# ADDENDUM FIVE GATEWAY SCULPTURES AT BLUE GOOSE HOLLOW CONTRACT NO. D-16-006-201 CITY OF CHATTANOOGA, TENNESSEE

The following changes shall be made to the Contract Documents, Specifications, and Drawings:

#### I. Revised Drawings

JEHGEN/BRY EHGINEERING, PLLC 1653 EAST MAIN ST ROCHESTER, HY 14609 585-482-8130 DHH: JR MARCH 23, 2017 REVISED A APRIL 24, 2017 REVISED A PECEMBER 27, 2017 SHEET 2 OF A

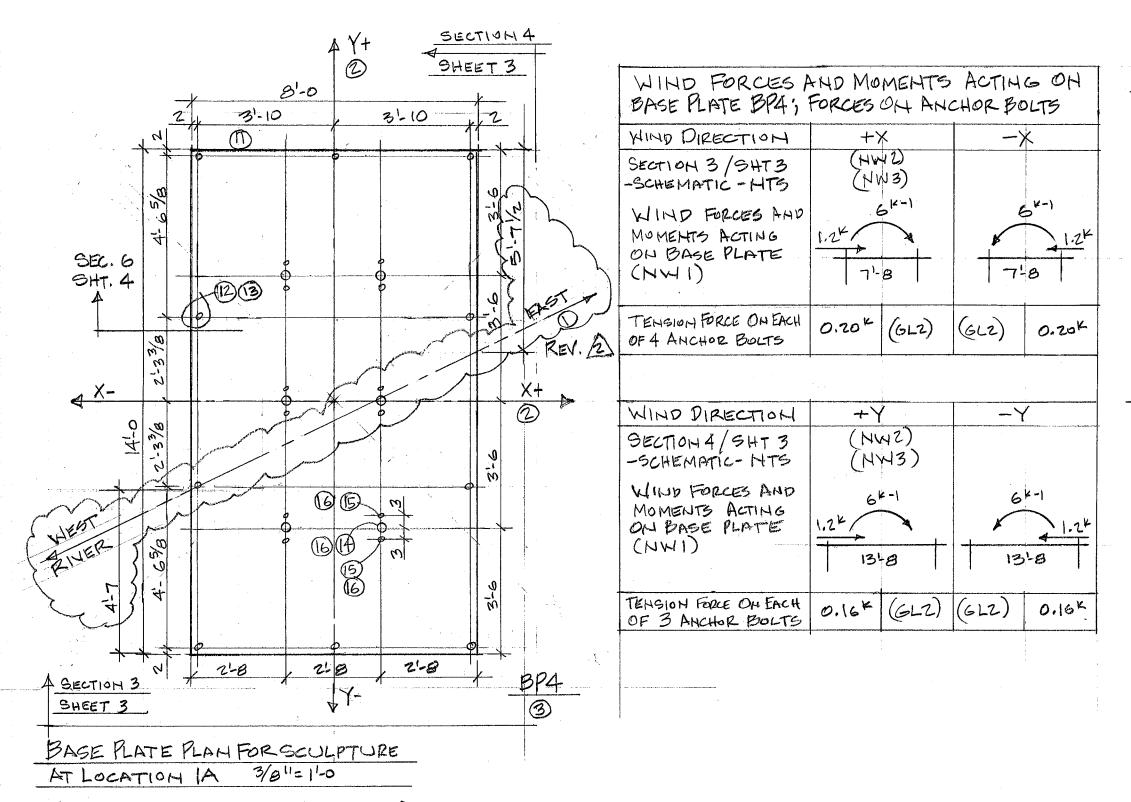
- 1. Revised drawings are included for the baseplate layout, replacing Sheets 3 & 4.
- 2. Due to foundation loading changes reflected in these drawings, revisions to the concrete foundation dimensions, reinforcing schedule and placement, depth of excavation, number and location of helical piers, and the size, thickness or grade of the helical pier top plate may be required prior to construction. Consequently, the quantities for pay items may be increased, decreased, or removed in order to accommodate the revised loading requirements.
